Subject: Duke Energy Corporation
Oconee Nuclear Station - Units 1, 2, and 3
Docket Nos. 50-269, 50-270, and 50-287

Revisions to Topical Reports DPC-NE-3000 and 3005 In
Support of Steam Generator Replacement
Response to NRC Staff Request for Additional
Information

**Duke Power Response To
Request for Additional Information Regarding Topical Reports
DPC-NE-3000 Revision 3
“Thermal-Hydraulic Transient Analysis Methodology”
and
DPC-NE-3005, Revision 2
“UFSAR Chapter 15 Transient and Accident Methodology”**

Figure 15-3
LARGE STEAM LINE BREAK
WITH OFFSITE POWER

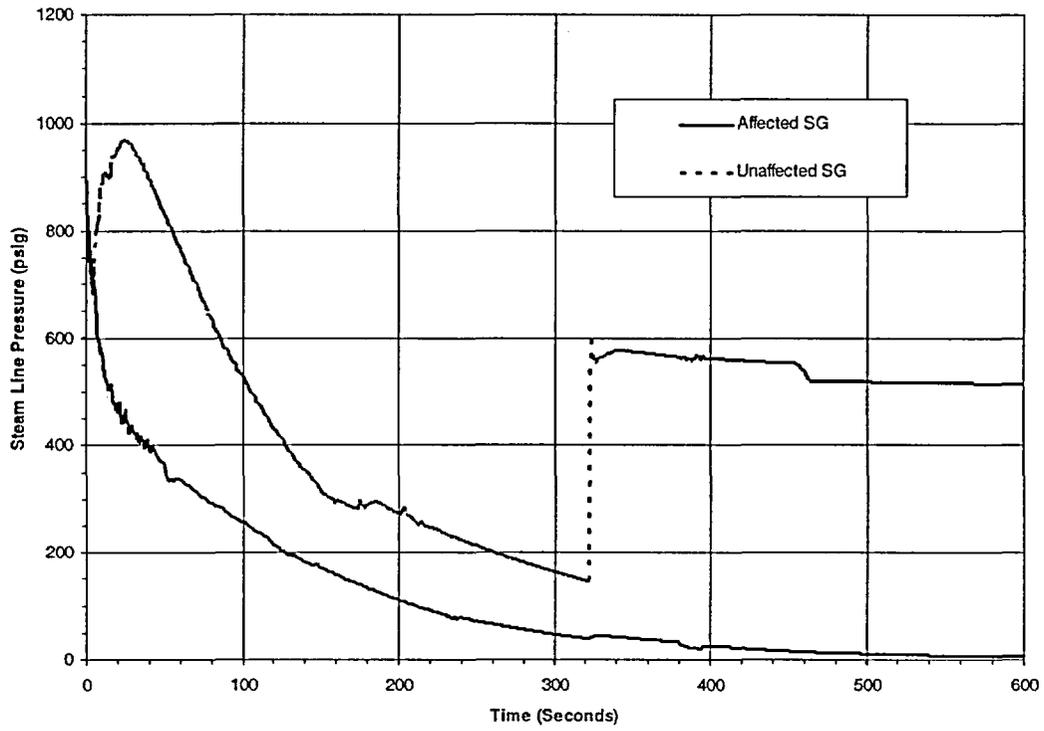
24. Page 5-36 to the revisions to DPC-NE-3005-PA states that the only significant difference between the transient thermal-hydraulic behavior with the new steam generators will be for the main steam line break analysis, in which the flow restriction orifices in the outlet nozzles will effectively reduce the minimum break size and blowdown rate. In addition the new steam generators will have a greater heat transfer area and a greater water mass. Differences in calculational models between RETRAN-02 and RETRAN-3D may also affect the result. In particular assumptions for phase separation within the steam generators and steam flow rate from the break may affect the result. Please provide main steam line break analyses similar to those in Chapter 15 of DPC-NE-3005-P for cases both with and without offsite power for the new steam generators with RETRAN-3D.

Response: The revised topical report text and figures (included after the response to Question 29) show the RETRAN-3D main steam line break analysis results for both with and without offsite power with the replacement steam generators. A brief summary of the result of the analyses is as follows. The steam outlet nozzle flow restrictors cause a slower RCS cooldown and depressurization rate, which provide more favorable results. For the with offsite power case the slower cooldown rate does not result in a loss of the subcritical margin according to the RETRAN-3D and SIMULATE simulations. Consequently, no detailed core thermal-hydraulic analysis was performed. For the without offsite power case, the RCS depressurization rate is slower, and the statepoint at the time of minimum DNBR is more favorable. Consequently an increase in DNBR margin is gained relative to the previous RETRAN-02 OTSG analyses.

The steam line break initially causes the pressure to decrease in both steam generators (Figure 15-3). Break flowrates (Figure 15-4) for both steam generators rapidly increase. *Break flow from the affected steam generator then steadily decreases, following pressure, until liquid break flow occurs at 260 seconds due to overfilling of the steam generator.* After the turbine stop valves close, break flow from the unaffected steam generator stops, *and the unaffected steam generator repressurizes until about 30 seconds.* Beyond this point in time, *overcooling in the affected steam generator decreases pressure in the unaffected steam generator due to reverse heat transfer. Then a water-solid condition is reached in the unaffected steam generator and it repressurizes. The affected steam generator is nearly fully depressurized by the end of the simulation. The uncontrolled main feedwater flow overfills the affected steam generator at approximately 240 seconds, and the unaffected steam generator at 214 seconds.*
